## Product Change Notification / RMES-21CWWT073

CCB 4629 Final Notice: Qualification of STA as an additional assembly site for LAN7500x, LAN8820x and LAN9730x device families available in 56L VQFN (8x8x0.9mm) package.

**CCB 4629**  
**Pre and Post Change Summary**  
**PCN#: RMES-21CWWT073**

## ASE

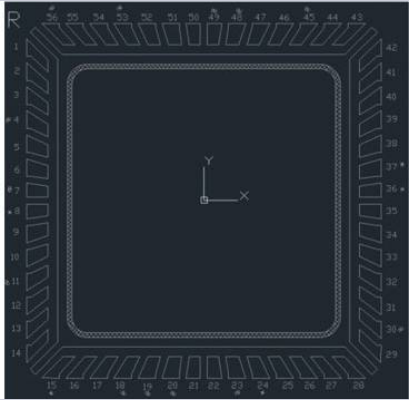
Lead frame Paddle size	240 x 240 mils
------------------------	----------------

## STA

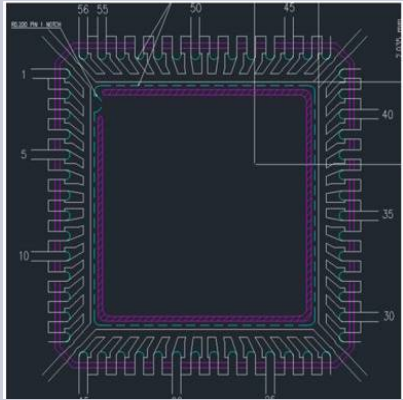
Lead frame Paddle size	236 x 236 mils
------------------------	----------------
